Nine Mile Point
Nuclear Surveillance Program-
A Summary

Linda Bond Downing
and
R.J. Scudato

Research Center
Piez Hall
SUNY Oswego
Oswego, NY 13126

Figure 2. New York State Department of Health sampling locations for air (1, [1A]), sediment (2, [2A]), fish (3), and TLDs (T). A 200 ft. wind rose from ESSERCO has been superimposed. Reprinted from Environmental Radiation in New York State 1988 Annual Report, New York Department of Health.

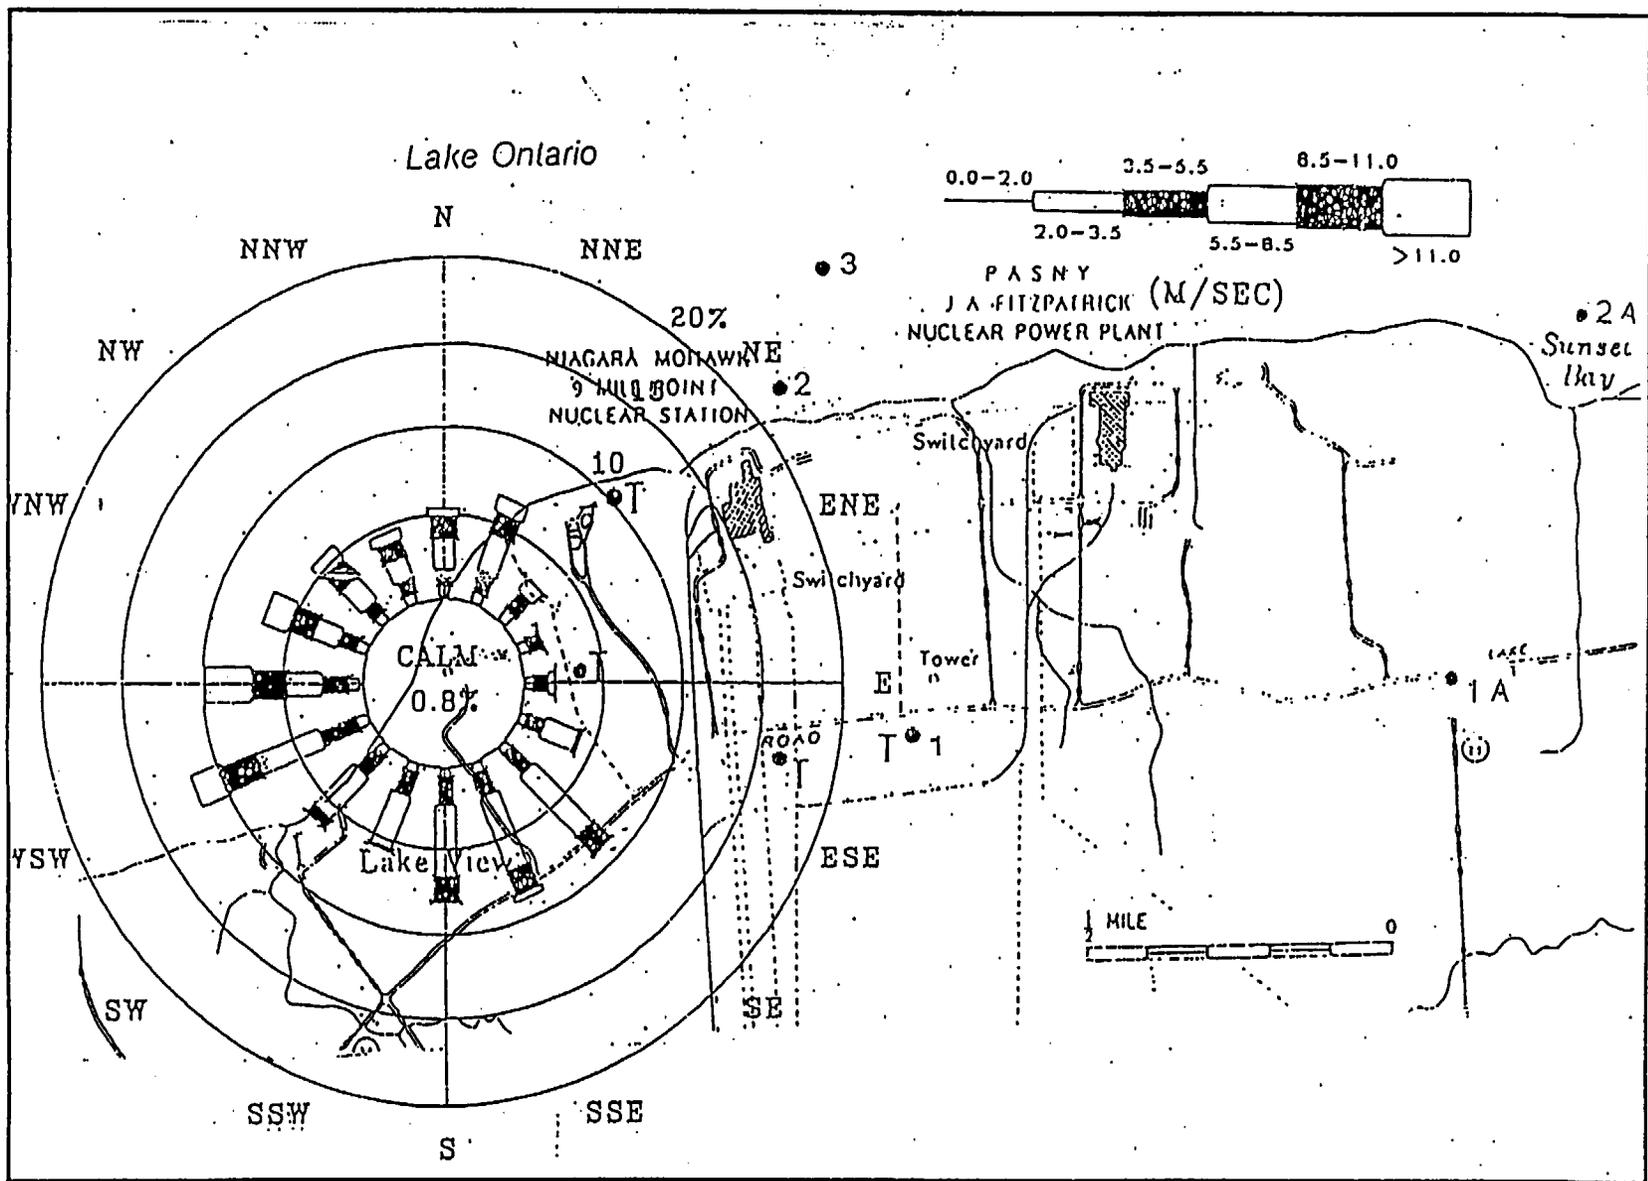
The NYSDOH annual reports use and identify a sole air sampling site as east-southeast of the operating nuclear facilities, labeled as Number 1 in Figure 2. Note that site number 1 is directly south. This site was in the downwind shadow zone for 20% to 25% of the time during the period 1986-1988 as shown by the wind rose of ESEERCO, Figure 2. The downwind shadow zone may be defined as the area which will be directly effected by wind dispersion of radioactive isotopes (NYPA). The cooperative agreement for NRC/NYS data identified the site at the intersection of County Rt. 29 and Lake Road, labeled as Number 1A in Figure 2, which is in the downwind shadow zone for 15% to 20% of the time. This air sampling site was changed four times from 1976 through 1988 by the NYSDEC and NYSDOH. Site A376101 existed during 1976-1977, site 3767001 existed during 1978-1980, site 3767003 existed during 1981-1987, and site 3767001 was once again monitored in 1988. The NYSDEC did not publish maps in their annual reports and there are no changes in NYSDOH maps to reflect these site changes, nor was any reason given for these sampling site changes by either agency. Some of the Utilities' (1988) off-site environmental stations are depicted on Figure 3 which is a copy from the New York Power Authority's annual radiological report.

- o Having only one air particulates site (Number 1 or 1A on Figure 2) in a southerly or east-southeasterly location from the reactors and emission points does not adequately ensure that the point source is being monitored appropriately by the NYSDOH, since there are two significant lobes of wind direction as shown by the ESEERCO wind rose for 1986-1988 on Figure 2. The air particulate sampler should be located to the east-northeast of the nuclear facilities; however, effective monitoring of air particulates is dependant on various wind patterns, and obstacles such as buildings and/or trees may influence the winds (Ballentine, personal communication). Also, no assessment or comparisons can be made from only one air station. The NYSDOH should reconsider the location and number of air sampling sites.

- o The four locations of the NYSDOH TLDs (1985-1988) do not take into consideration the prevailing or seasonal variations of wind direction. In fact, two of these monitors are located in the area of lull winds (Figure 2). These TLDs should be placed around the NMP site to effectively sample air relative to prevailing wind directions.

Figure 3. New York Power Authority sampling locations for water (03, 08, 09, 10, 11), \triangle environmental stations and \blacktriangle TLD locations. Reprinted from 1988 Radiological Environmental Surveillance Report, New York Power Authority.

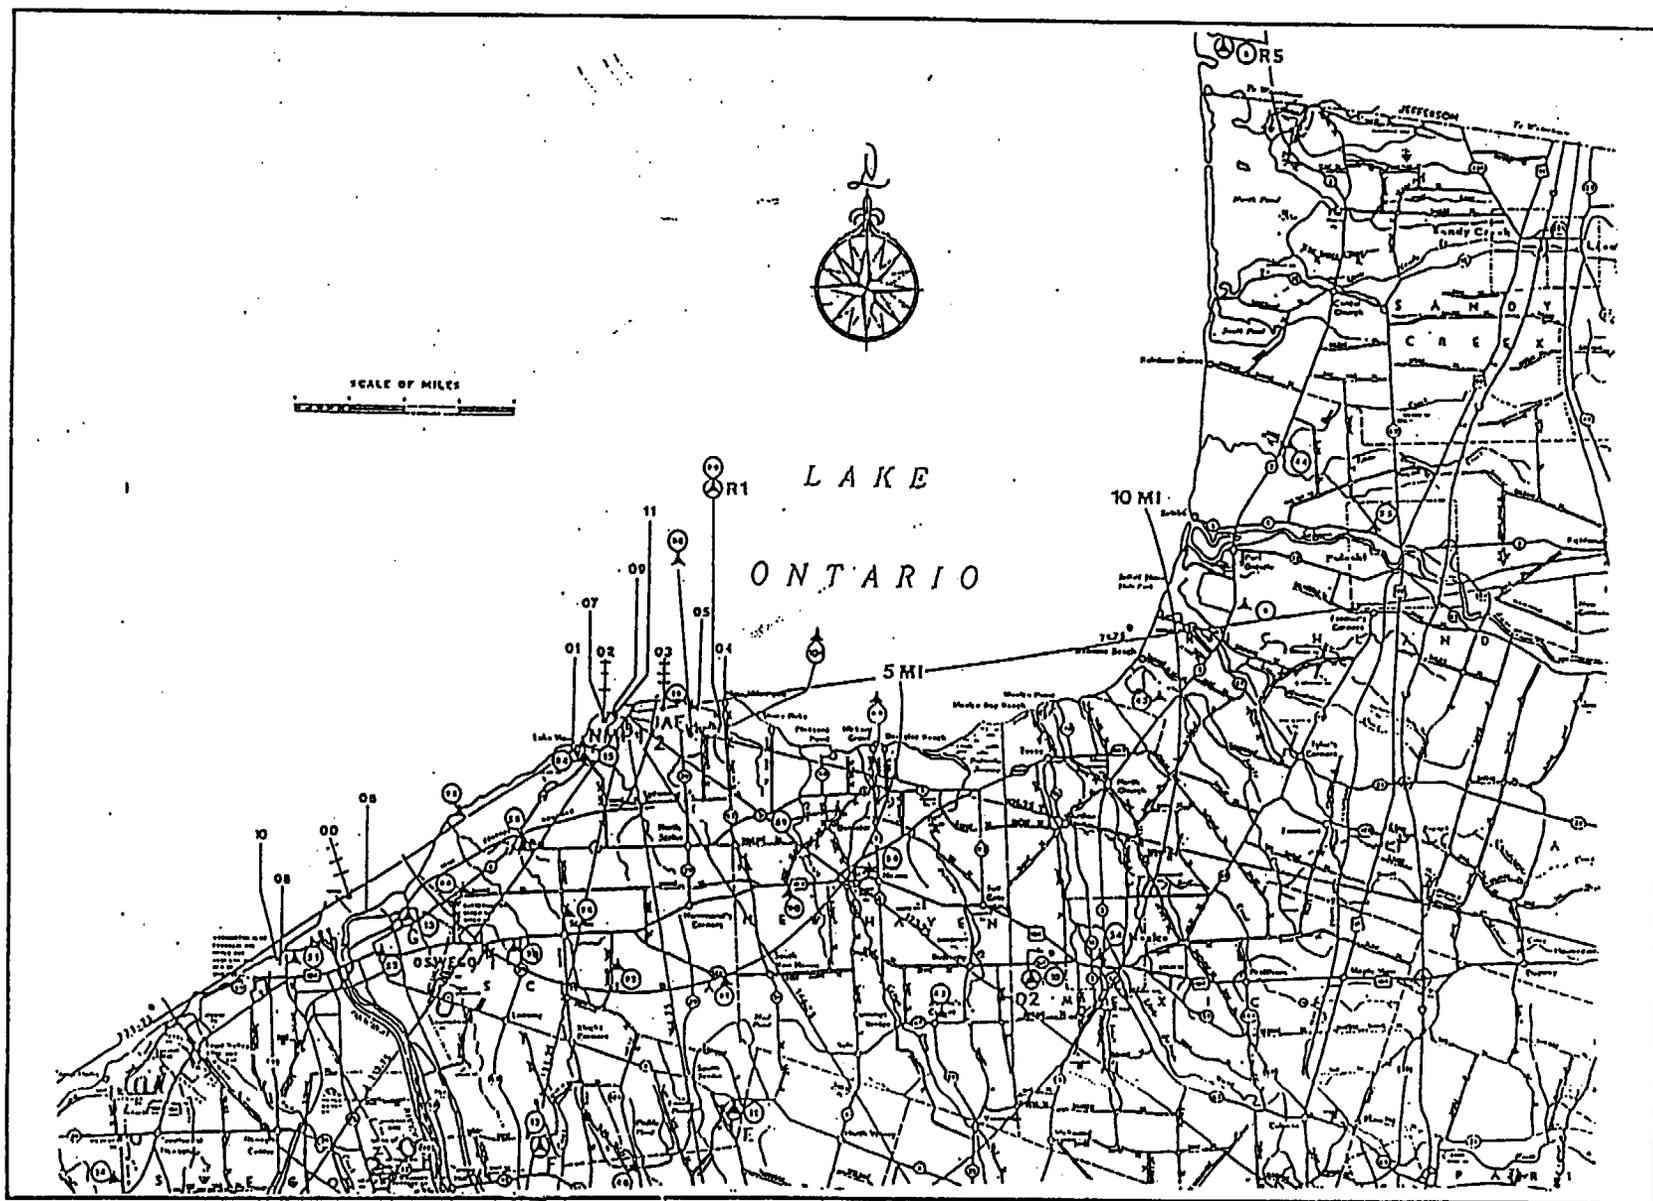
- o Wind roses of the Empire State Electric Energy Research Corporation (ESEERCO) for the period 1986-1988, indicate that any one station in New Haven will be down wind 10% - 25% of NMP (see Figure 3). Without the specific location of this sampling site it is difficult to relate or compare data. For example, the greater the distance from the facilities, the greater the wind dispersion, thereby minimizing and lessening crop exposure to radionuclides. The NYSDOH should consider monitoring the New Haven site with additional sites established in the Scriba and/or Mexico area. Selection of additional sites should be made after a careful evaluation of prevailing wind patterns.

Figure 4. New York Power Authority sampling locations for milk (4, 7, 16, 50, 55, 60, and 65). Other sites illustrated but not used for sampling are milk animal farm sites and previous farms sites. Reprinted from 1988

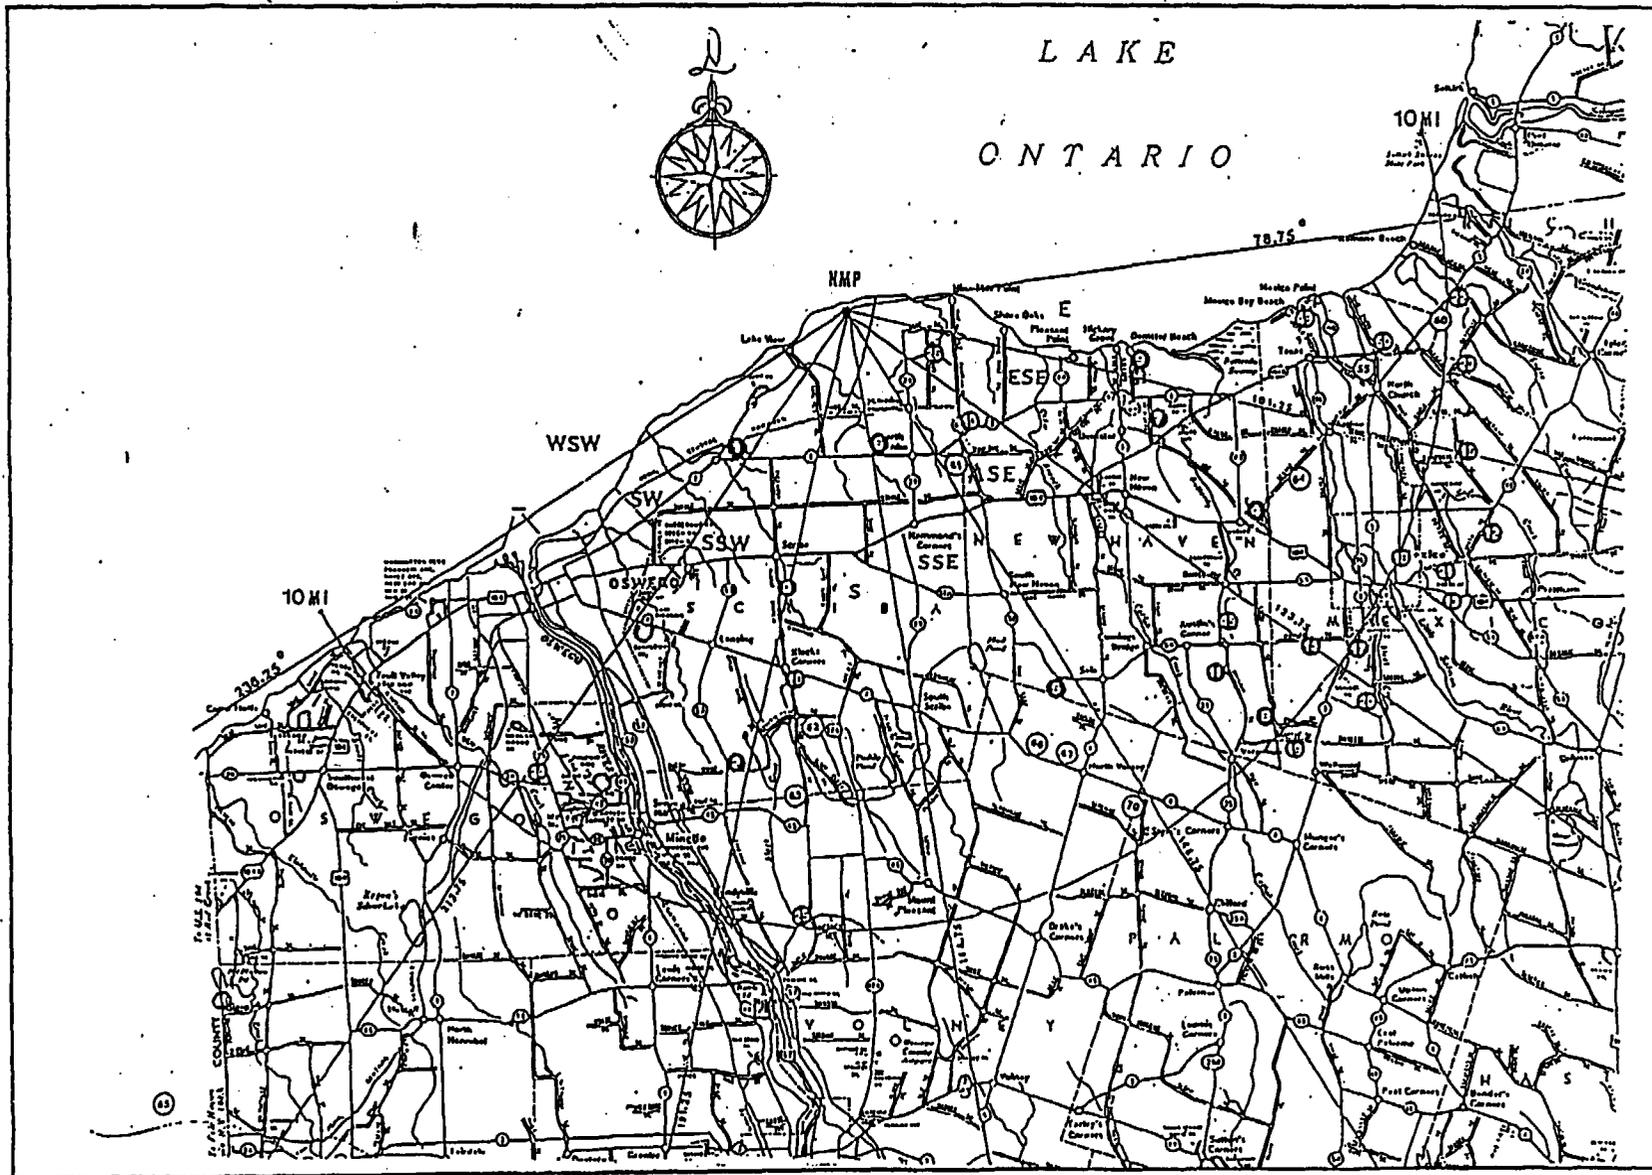
these farms be established from Figure 4. Rosin and Jones of the Oswego County Environmental Division (personal communication) did not know how long these farms have had milk sampled by the NYSDOH. One of these milk sampling sites is sampled by the Niagara Mohawk Power Corporation/ New York Power Authority (NMPC/NYPA) and is a homogenous split sample (NM).

Figure 6. New York State Department of Health sampling locations for air (A), milk (M), water (W), TLD (T), fish (F), sediment (S) and vegetation (V).

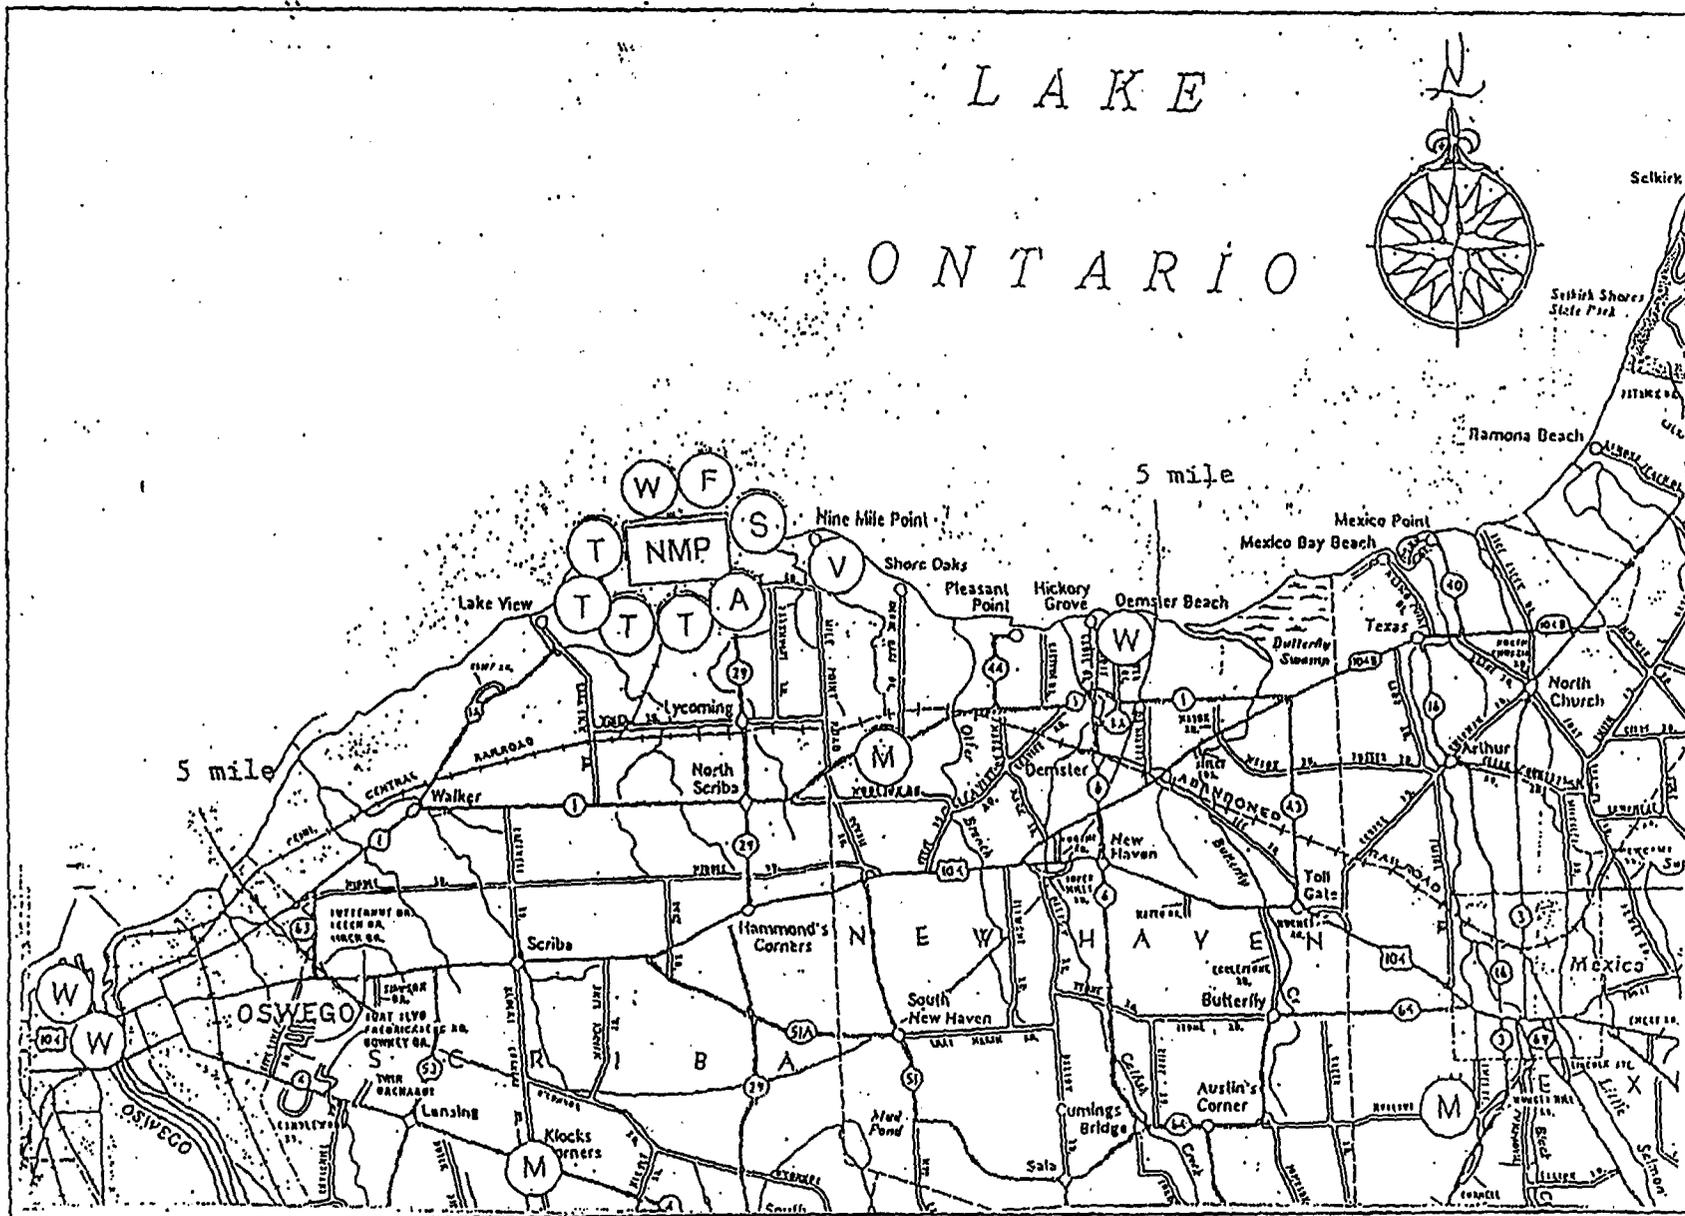
- o The open environmental area north of NMP, Lake Ontario, see Figure 6, is not being monitored for airborne releases, but should be. This region accounts for fifty percent of the perimeter around the plant. Monitors could be placed on buoys from spring to fall.

Figure 7. New York State Department of Health for Scriba Air TLD monitoring data from four locations for quarterly sampling for the period 1983 - 1988.

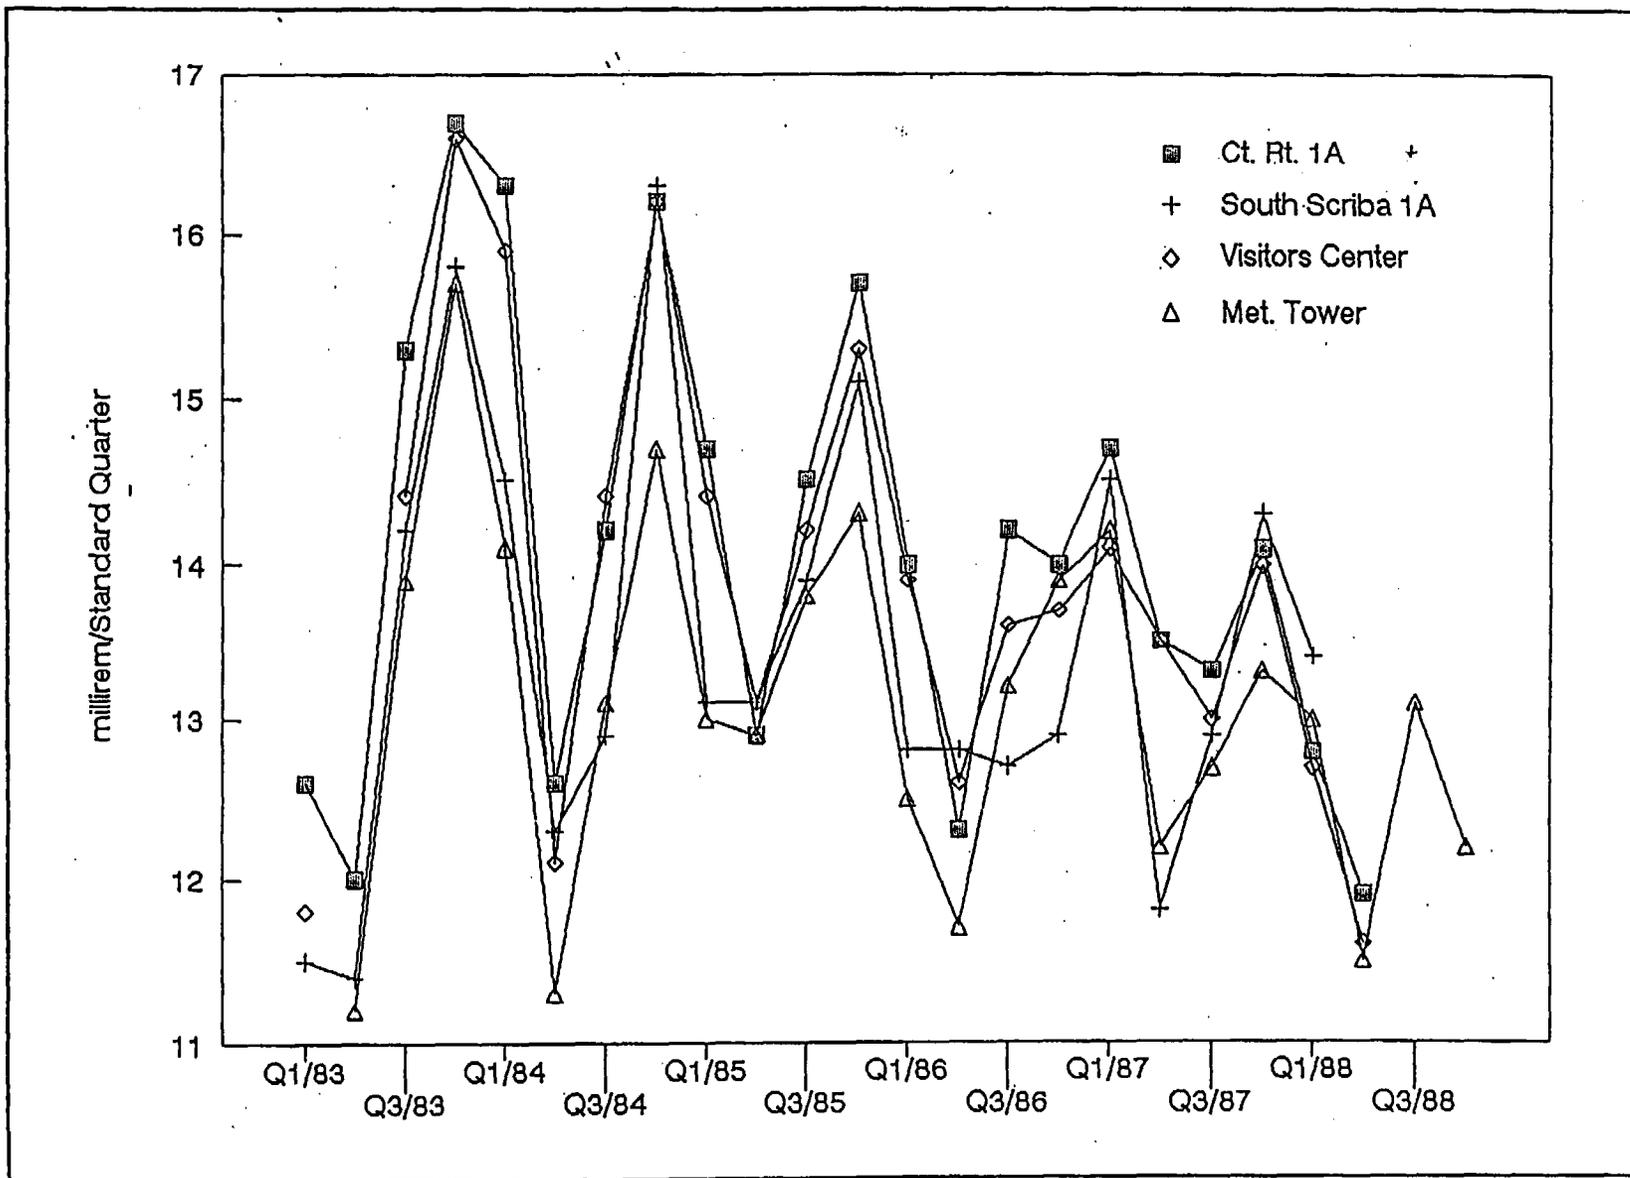
- o The NYSDOH 1988 location changes of the TLD monitors do not take into consideration prevailing or influencing wind directions. Due to the seasonal variation of the TLDs depicted in Figure 7, additional investigation and/or modelling studies by the NYSDOH should be performed to assess local wind patterns and the effect on TLD monitor placement. Information regarding the D/Q value, which determines the site location of the TLDs should accompany data. Also questionable is why the TLDs were moved in 1988 when previous monitoring data indicated a higher D/Q at the former sampling locations.
